Safety Evaluation Report

University of Wisconsin

Safety Evaluation Report Related to the Renewal of
the Facility License for the TRIGA Reactor at the
University of Wisconsin

March 2011
Office of Nuclear Reactor Regulation
U.S. Nuclear Regulatory Commission

Figure 2.1 Historical Pool Water Makeup Trend

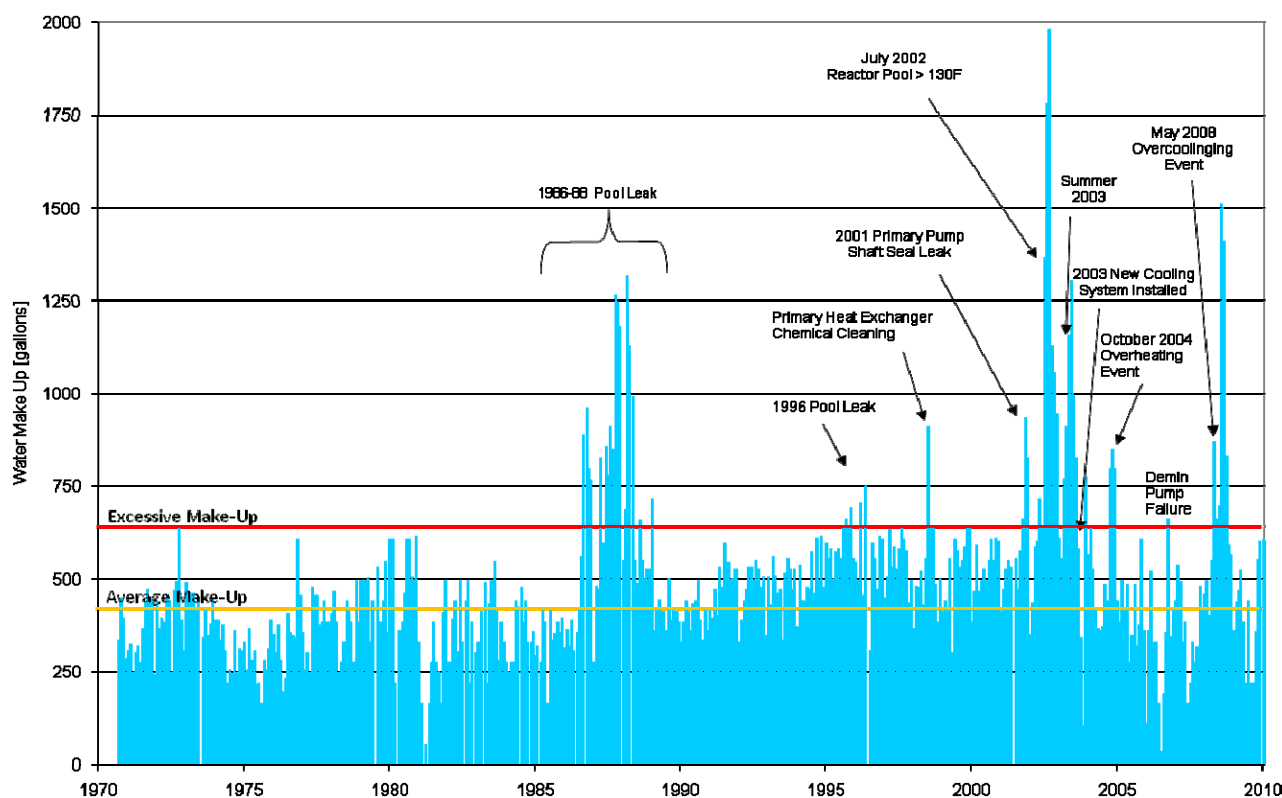
In the event that the pool leak reinitiates and an increased trend in leakage is identified, the licensee has established limits for further operation of the facility. Through the licensee response to RAI No. 1 in a letter dated June 16, 2010 (Ref 20), the licensee stated that it will adhere to the mandates of the UWNRRSC, which, in 2003, mandated a reactor shutdown and an immediate repair if either of the following conditions occurs:

- (1) pool water makeup greater than 2,200 gallons per month, or
- (2) pool water activity approaching 80 percent of 10 CFR Part 20, Appendix B, Table 2, water effluent concentration limits for isotopes with half-lives greater than 24 hours.

As the RSC limitations would prevent the licensee from exceeding 10 CFR Part 20, Appendix B, Table 2, limits, the NRC staff finds the above commitment acceptable.

Figure -1 Organizational Chart

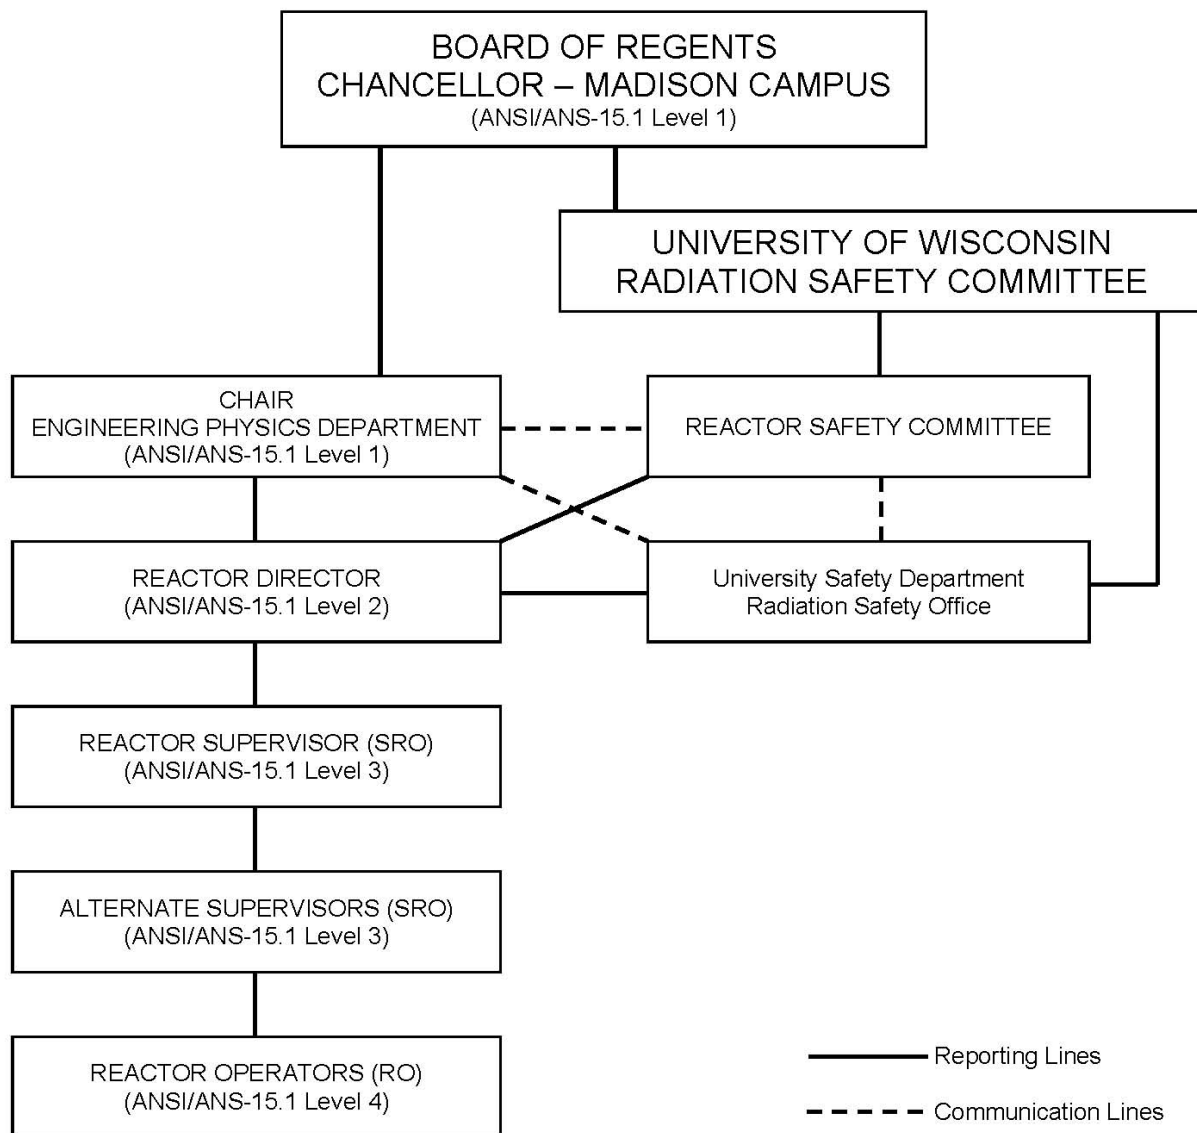
Responsibility for the safe operation of the reactor facility is vested within the chain of command shown in TS Figure -1, which depicts the licensee's organization. The organizational

responsibilities delineated in TS Figure -1 are consistent with the guidance in provided in NUREG-1537 and ANSI/ANS-15.1-2007 and are, therefore, acceptable to the NRC staff.

Certain Level 1 responsibilities of the Board of Regents of UW, the holder of the reactor license, are delegated to the Engineering Physics Department chair. The licensee revised the organizational chart (Figure -1) to reflect this clarification.
